5.1 NO. 110 COOGEE STREET MOUNT HAWTHORN (LOT: 228 D/P: 2503; LOT: 229 D/P: 2503) - PROPOSED THREE GROUPED DWELLINGS (AMENDMENT TO APPROVED)

To consider an application for development approval for an amendment to the previous development approval for three grouped dwellings at No. 110 Coogee Street, Mount Hawthorn (the subject site).

## PROPOSAL:

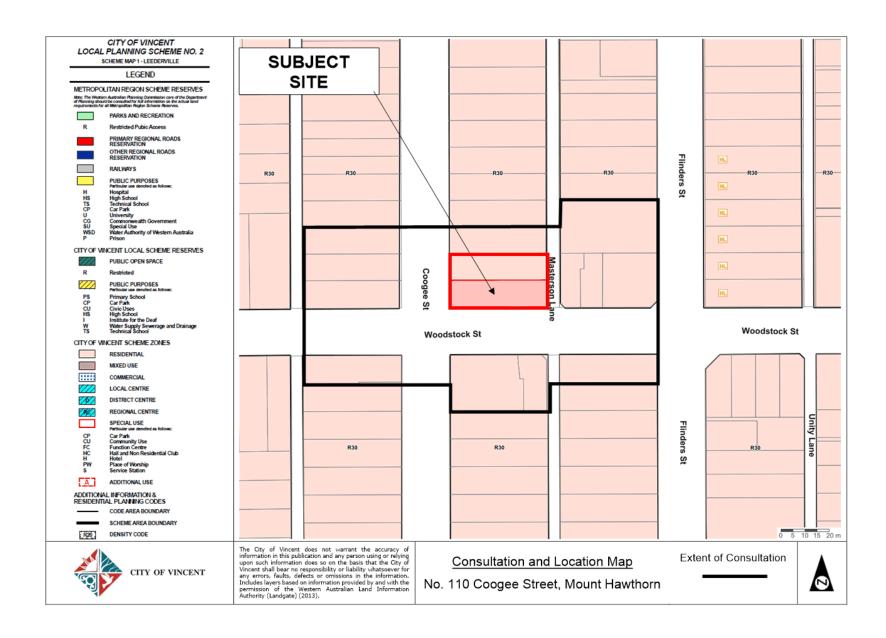
The R Codes deemed-to-comply standards relating to external fixtures outline that they shall not be visible from the street, shall be integrated with the design of the building or shall be adequately screened.

The meter box for the development is proposed to be located on the Unit 1 front fence, setback 1.2 metres from the Woodstock Street boundary. The meter box would service all three units.

Should the application be approved, it is recommended that a condition be imposed that requires the meter box to be painted to match the colour of the fence to which it is attached. This would ensure that the proposed meter box would not have an adverse impact on the amenity of the visual character of the existing streetscape.
